Ponde Place

Residential Apartment Community

Mansfield, Connecticut

Eastern Connecticut Environmental Review Team Report

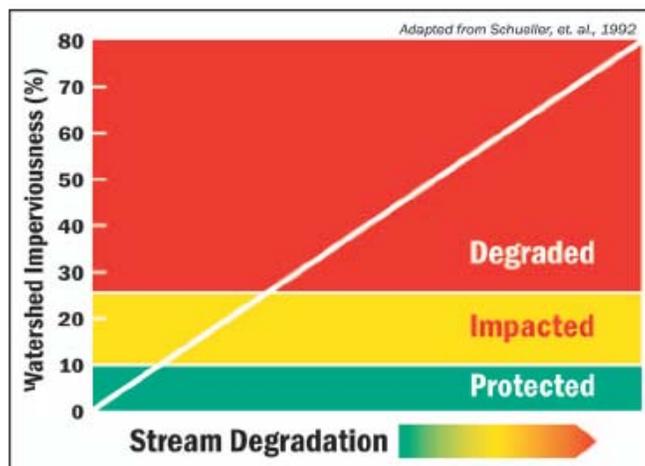
Impervious surface totals provided by the developer at the ERT meeting were in the range of 40 percent of the parcel. This would add 18 acres impervious surface to the property. Of this total approximately (gross estimate) two thirds, 12 acres (10.7 percent) is within the 112 acre watershed east of the drainage divide. Thus, upon completion, this small, 112 acre watershed will be well into the "Impacted" category for water quality and approaching the 26 percent "Degraded" rating as a result of the proposed increase in impervious surface.

Graphic 8 and 9 -

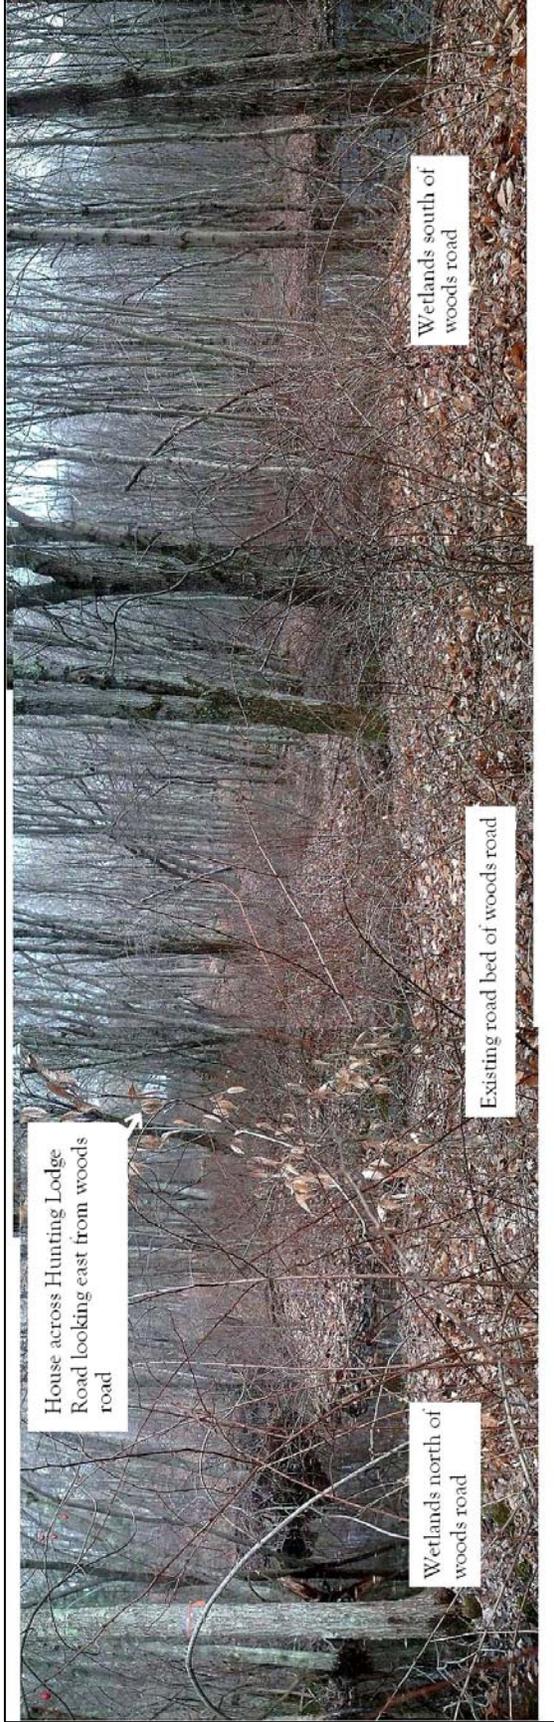
The field walk showed the team members that the track record for successful soil erosion and sediment control measures at construction projects in this immediate vicinity has not been good. Below can be seen images of the walking trail being constructed abutting the property along Hunting Lodge Road taken on the date of the field review.

Unprotected loose soil is prone to gullying with the transport of fine grained material down slope. Here unprotected loose soils have experienced gullying with the resulting mini-delta at the base of the runoff slope.

Loose soils, poor execution of soil erosion protection and meager oversight (indicative of poor reporting to local authorities and poor municipal response to correct the problem) can only lead this reviewer to the inevitable conclusion that the wetland resources WILL be impacted during the construction of this project.
